TERN AREA KESTREL AND FALCON SUBSEA FACILITIES DECOMMISSIONING PROGRAMMES

23 February 2026 – Final for Approval

77IFS-188054-H99-0001-000

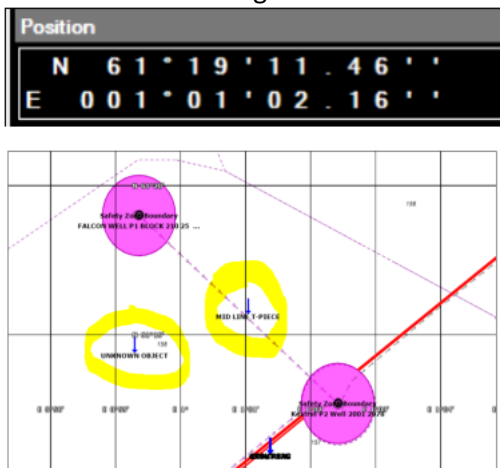
Table A-1: SFF Comments on Kestrel Falcon DP & TAQA Responses		
Comment	Code*	TAQA Response
Mid-Line T-Piece. The SFF's records confirm the presence of a 'Mid-Line T-Piece' at the following location:  Figure 1. Location of Mid-Line T-Piece & Unknown Debris. However, we have not found any mention of this in the Kestrel and Falcon DPs. The SFF would like to seek clarification on its status Q and is interested in knowing whether it sits proud on the seabed. If so, can it be removed? Unknown Debris The SFF note an item of unknown debris located 0.8nm from project (see Figure 1 for location). The position of the unknown debris is as follows:		The mid-line T piece is a T component in the pipeline that is beneath rock cover. This will be decommissioned in situ with the rest of this line. Regarding the unknown debris noted on FishSAFE (7 m high with a 2 m base). The area around the Falcon facilities was surveyed in 2024 in preparation for locating a drilling unit at Kestrel for P&A, nothing was found at this location. See chart data In Appendix 1 to this table. Oilfield related debris that cannot be recovered and other non-oil related debris identified during surveys will be logged, and data will be passed to SFF/Kingfisher for inclusion in FishSAFE, etc.
